AGENDA
PLANNING AND ZONING COMMISSION MEETING
CITY OF CREVE COEUR, MISSOURI
TUESDAY, SEPTEMBER 3, 2019
6:30 PM

UNFINISHED BUSINESS**1. Application #19-023: Master Sign Plan for Barnes Jewish West County Hospital Campus Pursuant to Section 405.955 Master Sign Plans.**

APPLICATION TO PLANNING AND ZONING COMMISSION #19-023: MASTER SIGN PLAN FOR BARNES JEWISH WEST COUNTY HOSPITAL CAMPUS

Figure 1: Image of the 3 main signs along N. Mason and Olive Boulevard.

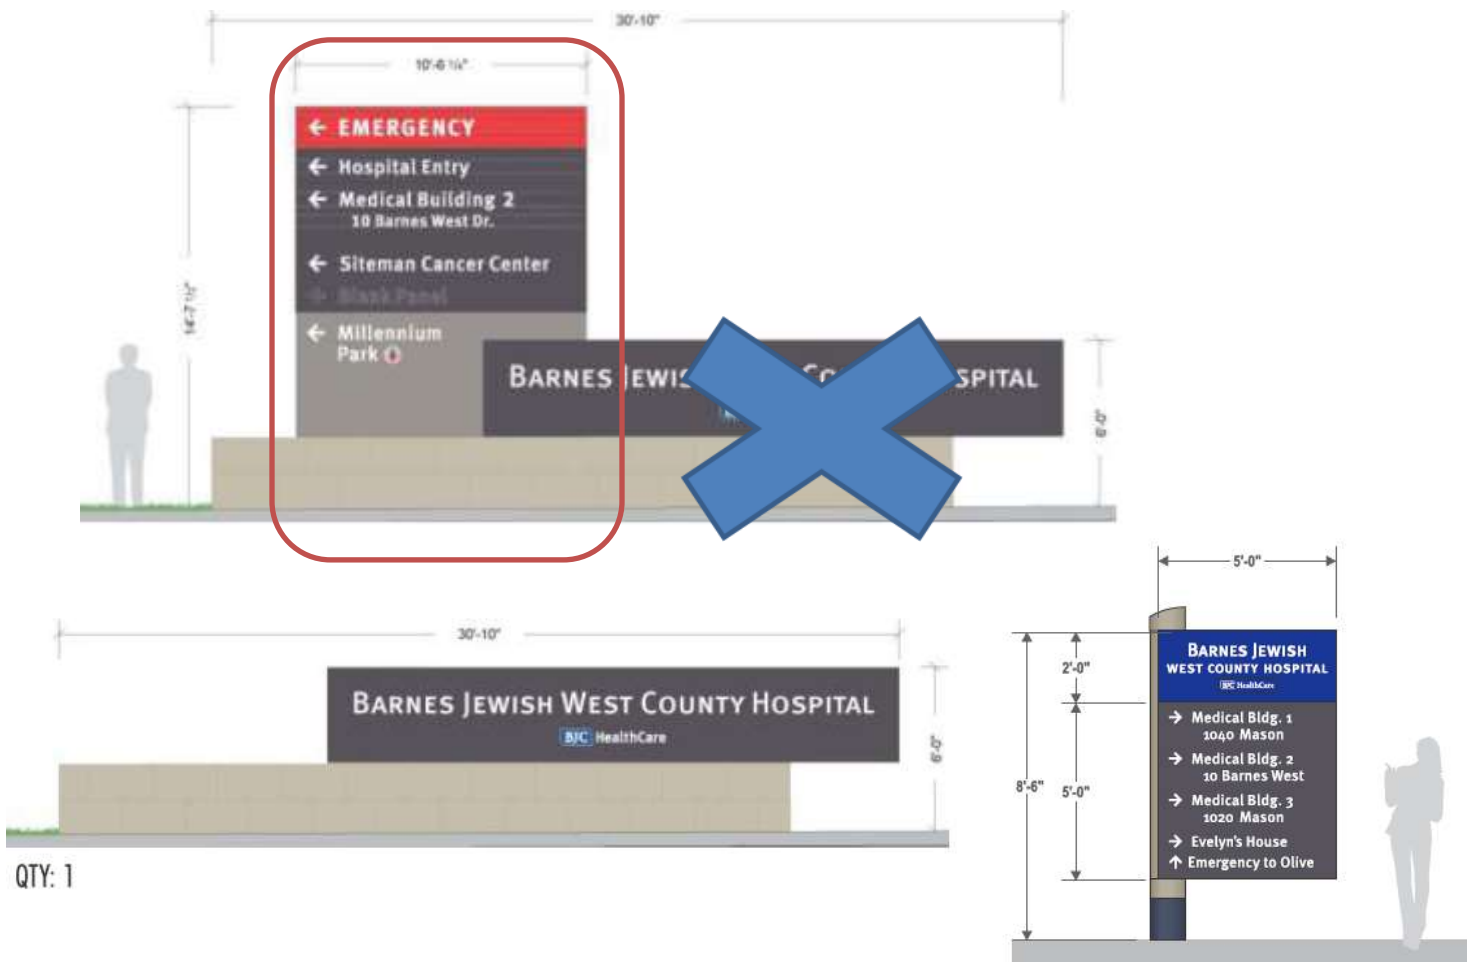
Staff recommends that Signs #1 and #3 at the entrances of Olive Boulevard and N. Mason Road should be of a masonry base, and the scale should be brought down to be consistent with one another, and serve to provide directional information. The campus identification portion of Sign #1 should be removed with the hospital text incorporated into the pylon sign.

Figure 2: Close-up of the Site Plan showing the number of signs and Type of Signs at the entrance of Olive Boulevard and Barnes West Drive.

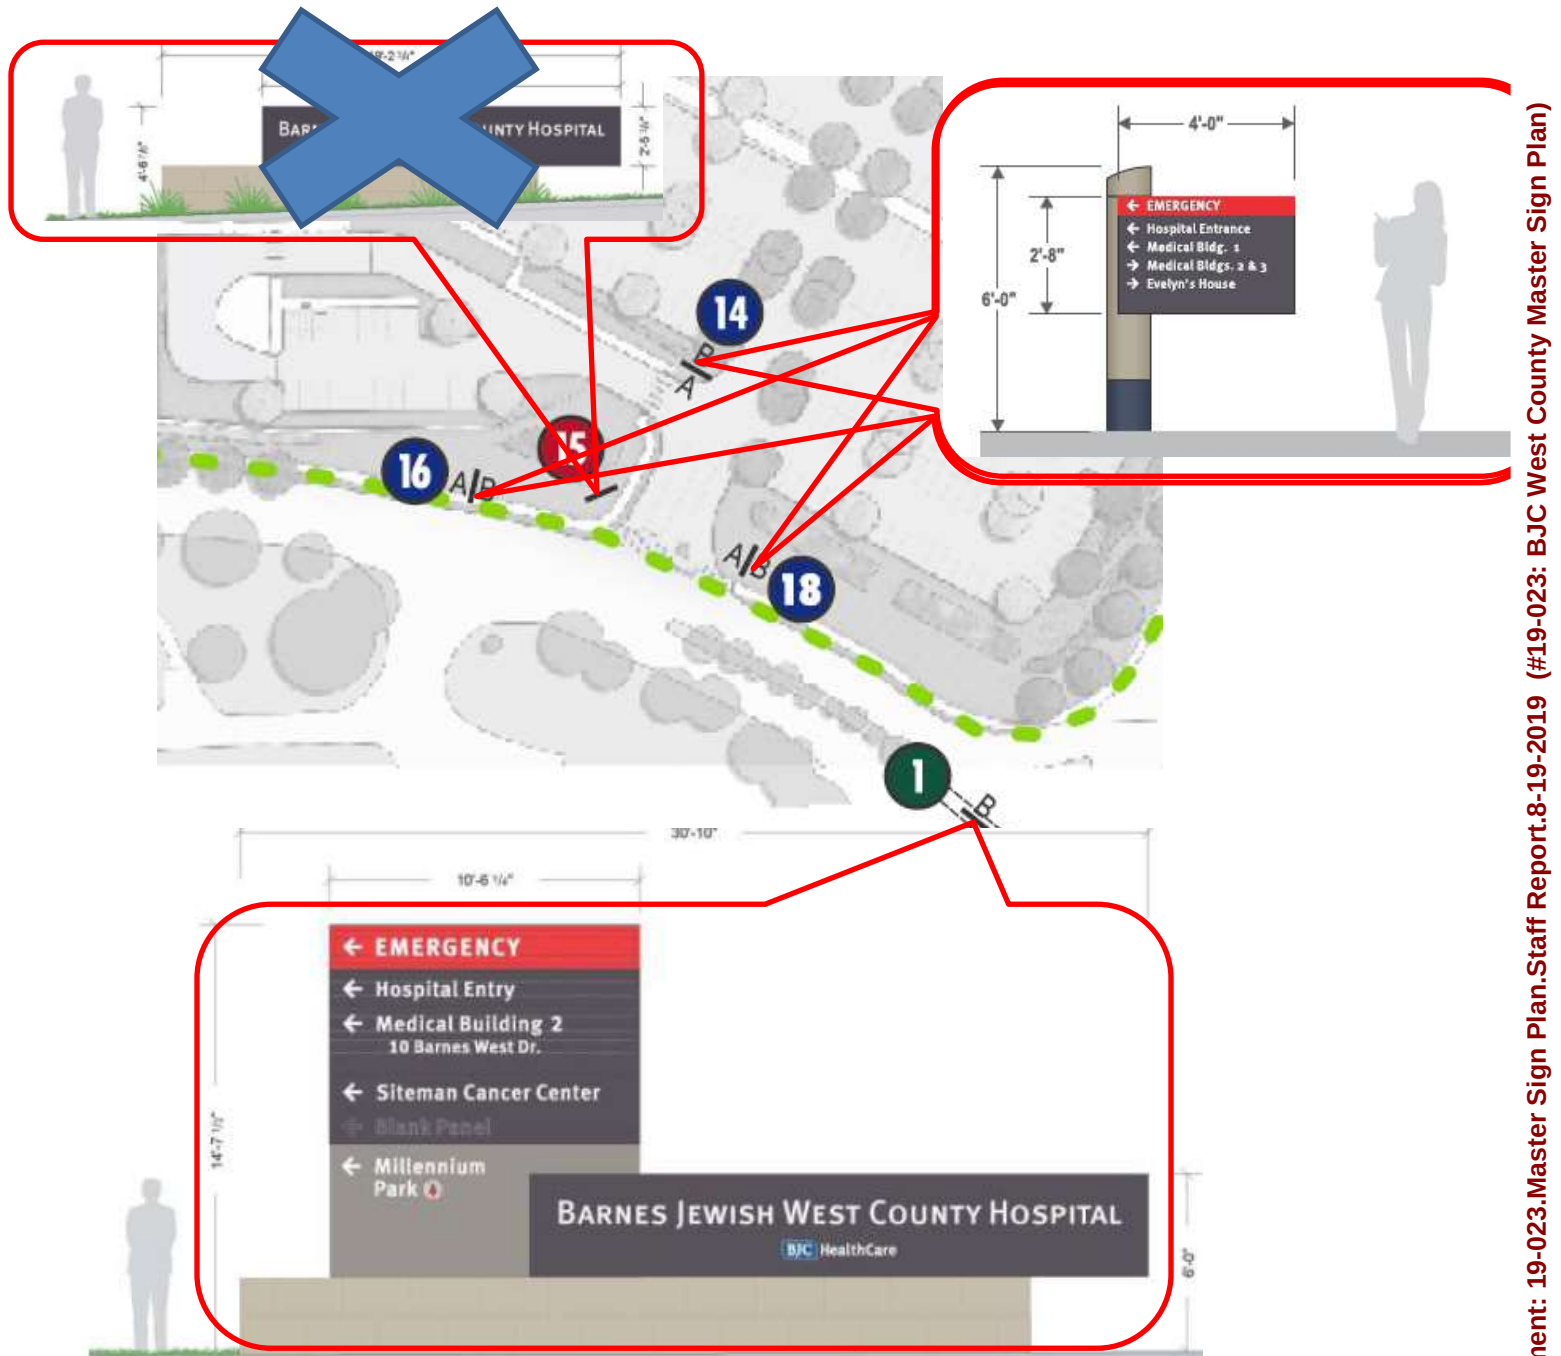
Staff is also concerned of the about the number of signs within the hospital entrance off Barnes Drive that would create clutter in the area. Sign 15 is unnecessary and should be eliminated to lessen the clutter within this area.
